**REMARKS**

The Official Action objects to the drawings as failing to comply with 37 CFR §1.84(p)(5). The Official Action draws specific reference to the reference numeral 39 in Figure 6, and reference numeral 42 in Figure 7, neither of which are identified in the specification.

Reproduced below is Figure 2 of the applied reference, modified only by shading the surface of the light intercepting mask 30. As is clear from this illustration, the opening defined by mask 30 is clearly not circular, contrary to the recitations of each of the present independent claims.

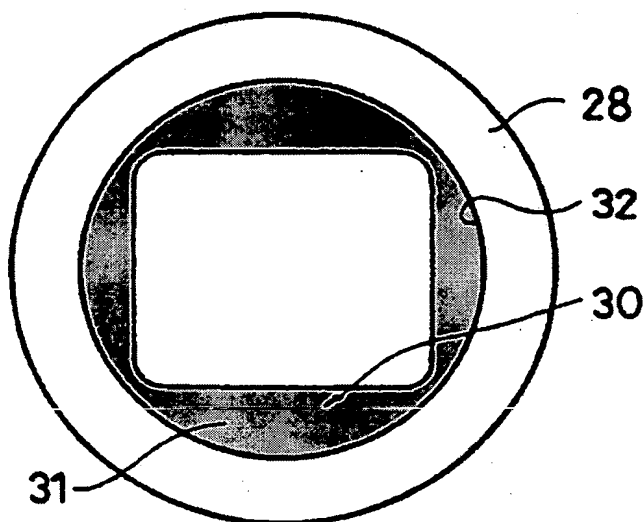
The Official Action identifies the various elements of the KOHMOTO et al. device construed as meeting the features recited by the rejected claims. Among these is the light intercepting mask 30 of KOHMOTO et al. considered to meet the recited flare stopper of the rejected claims. Among the features of the recited flare stopper is an inner periphery defining a circular opening.

Moreover, the non-circular shape of the opening in mask 30 of the reference is, as described on lines 61-62 of column 3, one of the most significant features of that device.
